## TECHNICAL MEMORANDUM

**PROJECT:** Salinas Valley Seawater Intrusion Model

**SUBJECT:** 2023 Model Updates to Address Groundwater Technical Advisory Comments

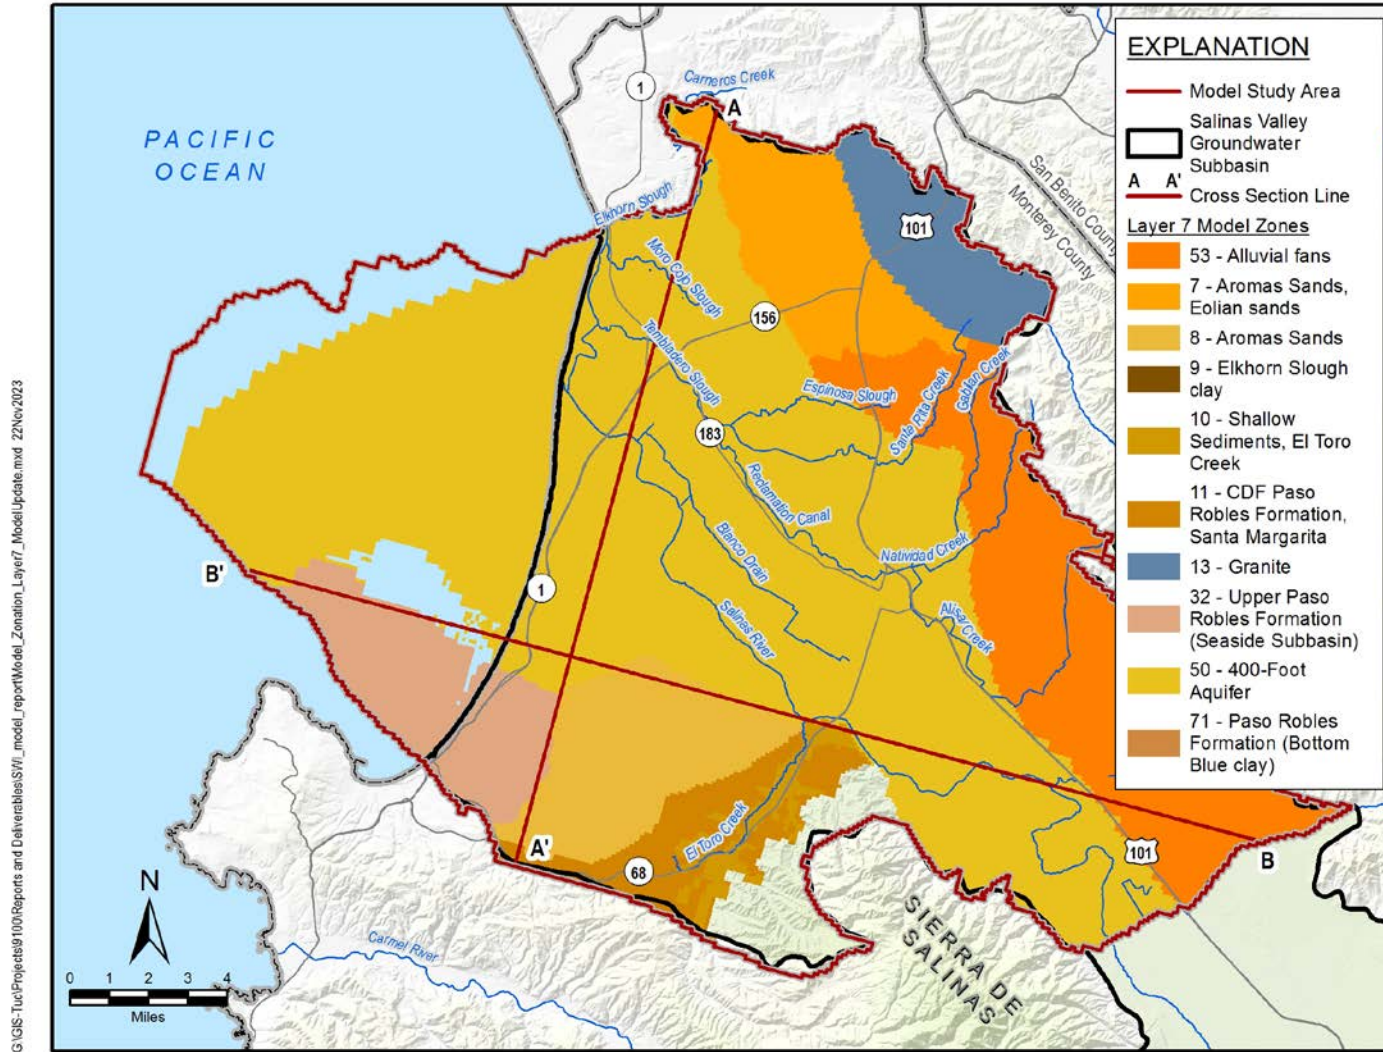
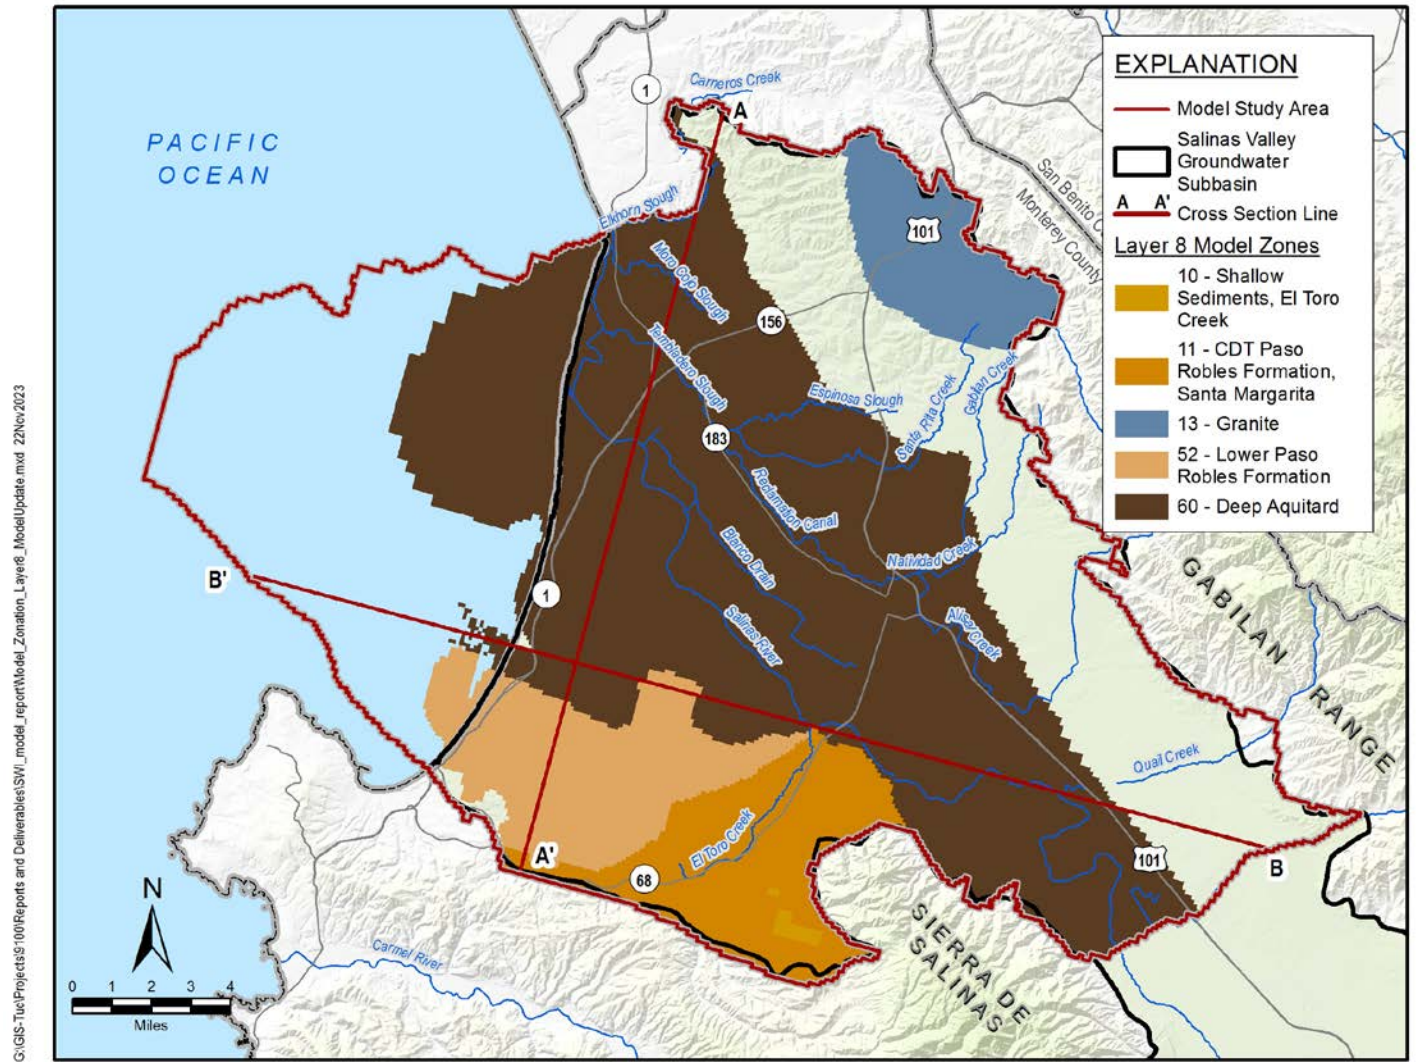
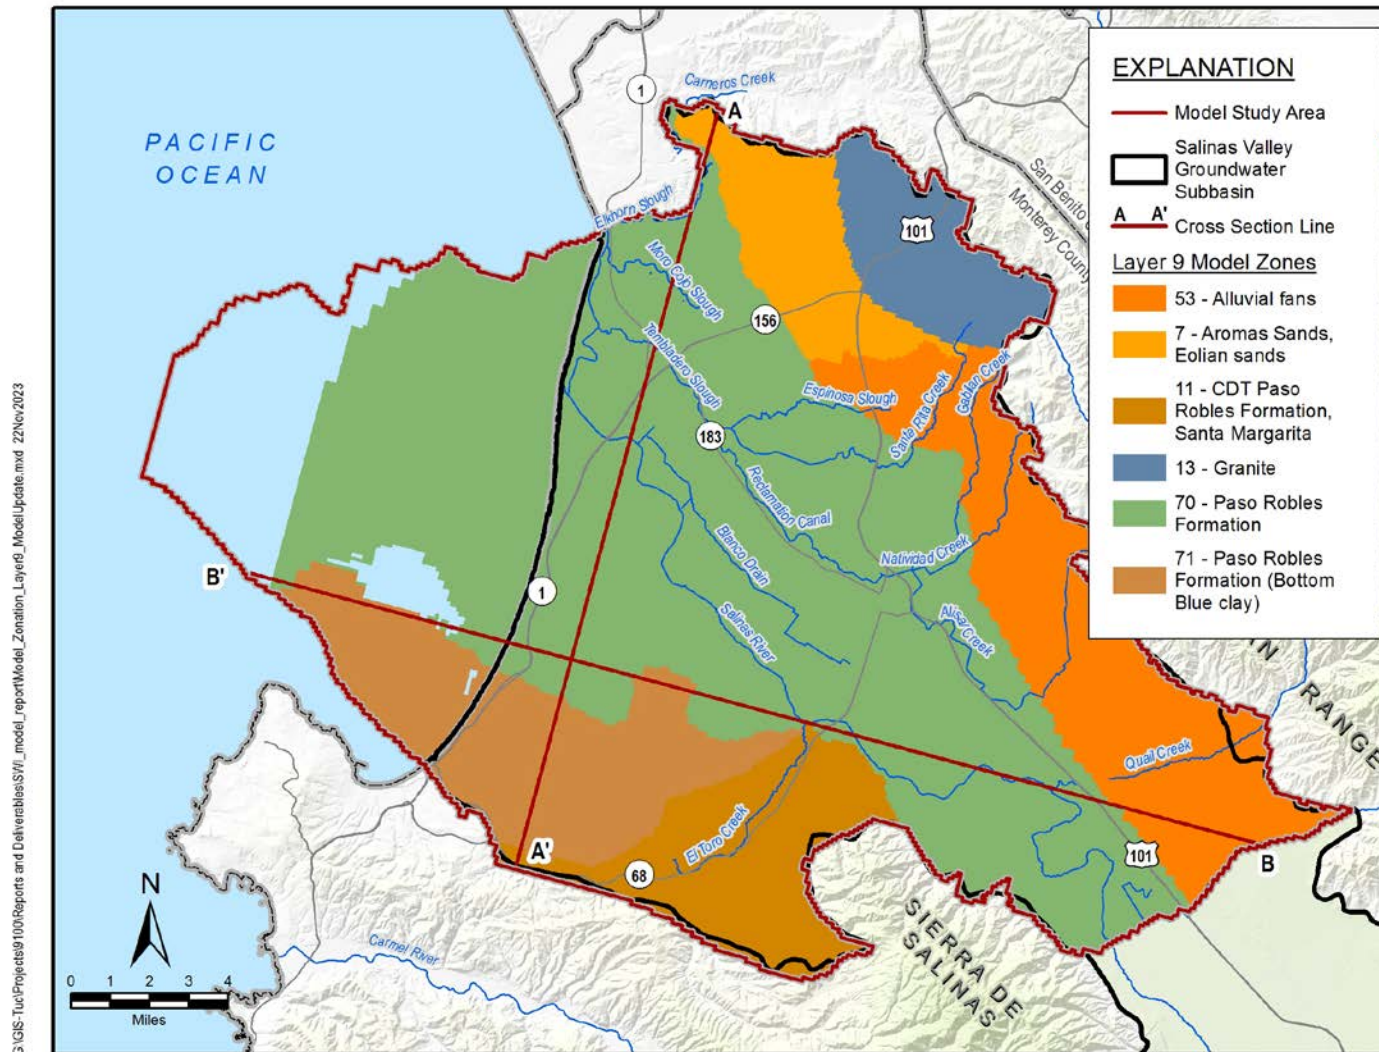
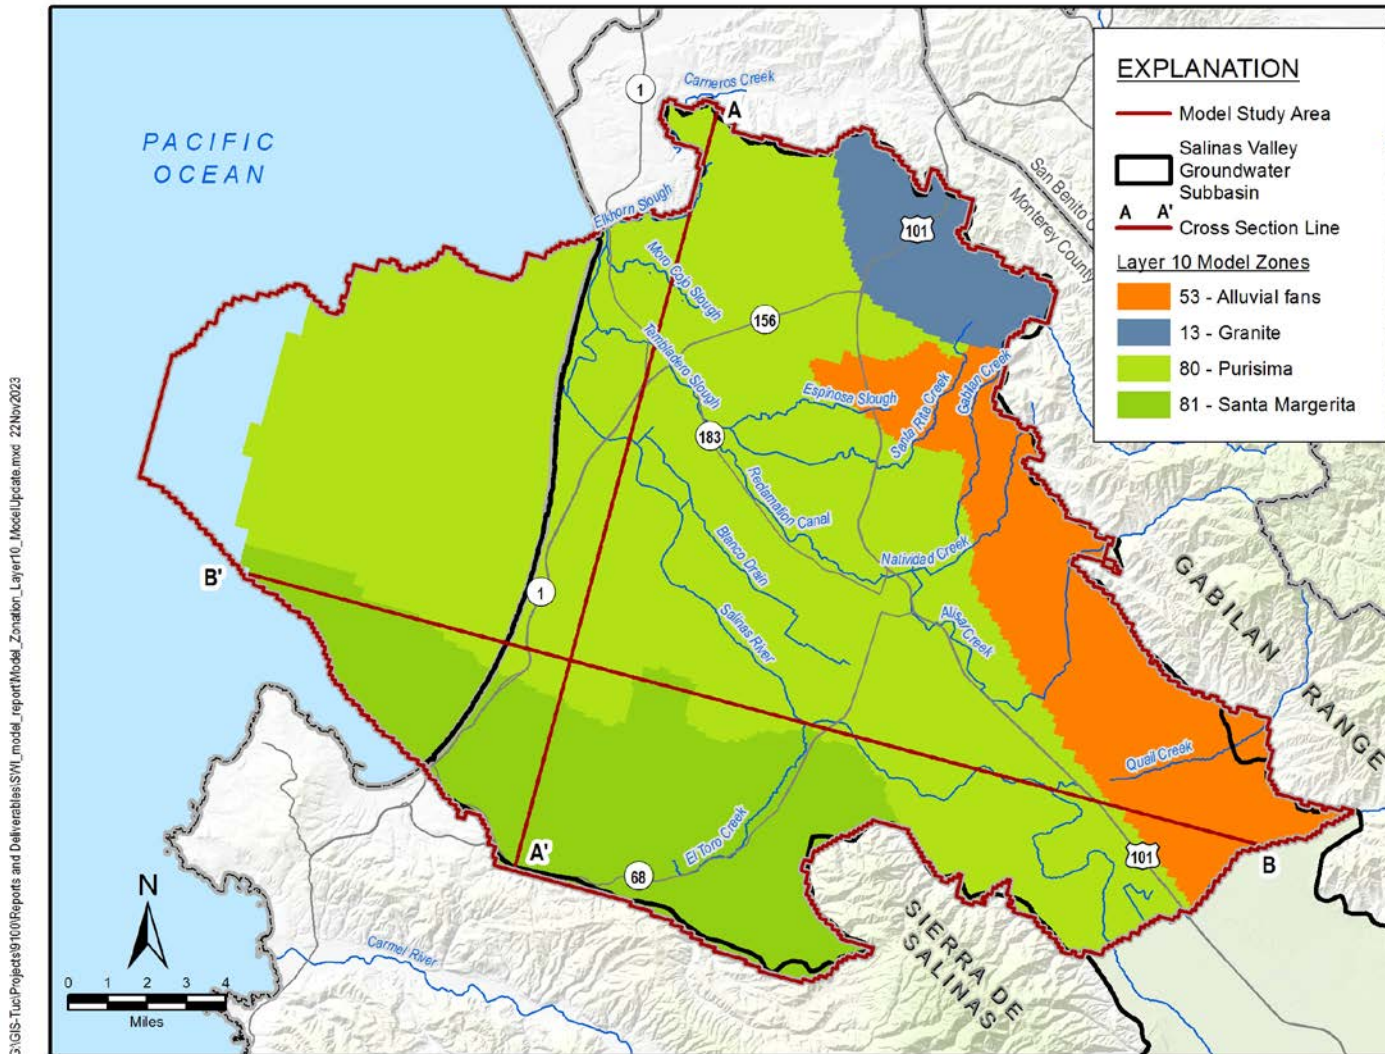
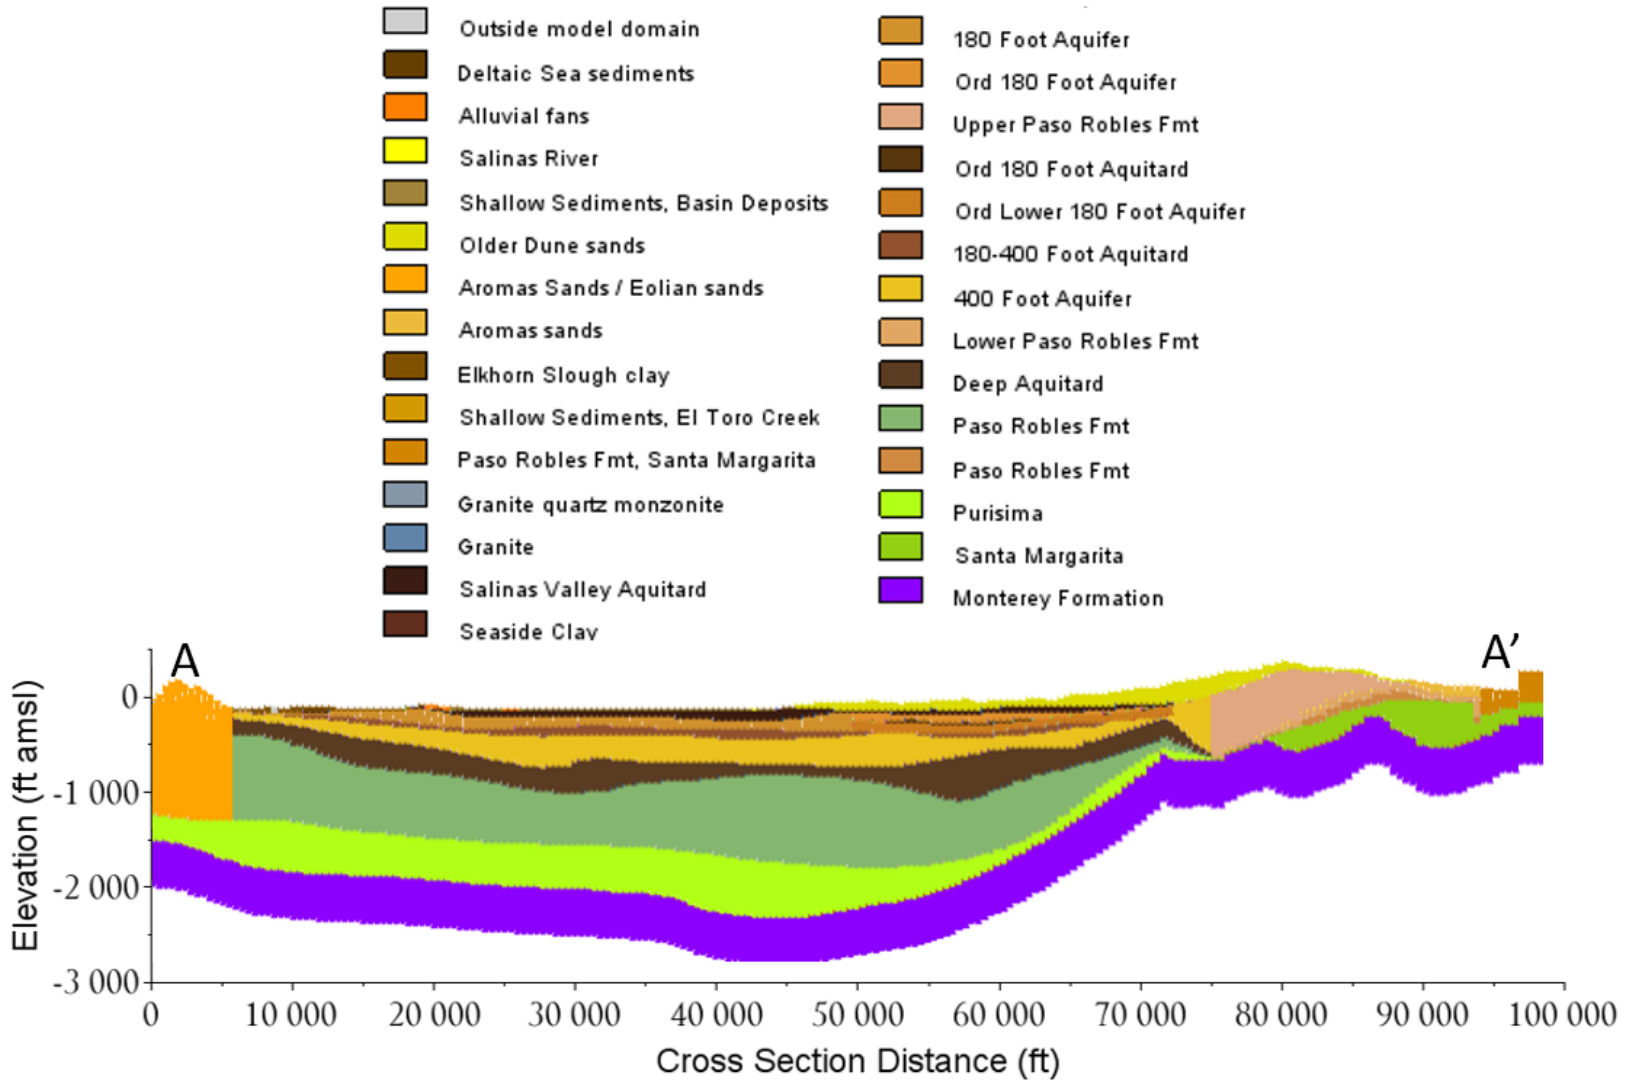
3. Adjust Monterey Formation uplift in the Monterey Subbasin based on more recent data

Previous geologic cross sections showed the Monterey Formation, which is considered the bottom of the groundwater basin, uplifting near the boundary between the Monterey Subbasin and the Seaside Subbasin. However, more recent geologic investigations show the Monterey Formation is located at greater depth and the GTAC recommended adjustments be made to reduce the uplift.

M&A adjusted the hydrostratigraphic units represented through the model layering and hydraulic parameter zonation in this area to reflect more recent understanding of the basin geology. The uplift of the Monterey Formation between the Monterey Subbasin and Seaside Subbasin was reduced by modifying the parameter zonation of the Monterey Formation in this area (zone 90) in the subject layers 7 through 10 to reflect the surrounding zones (400-Foot Aquifer, Deep Aquitard, Paso Robles Formation, and Purisima Formation). Then the elevations of layers 7 through 10 were adjusted to extend the surrounding formations through the area where the uplift had previously been delineated in the model.
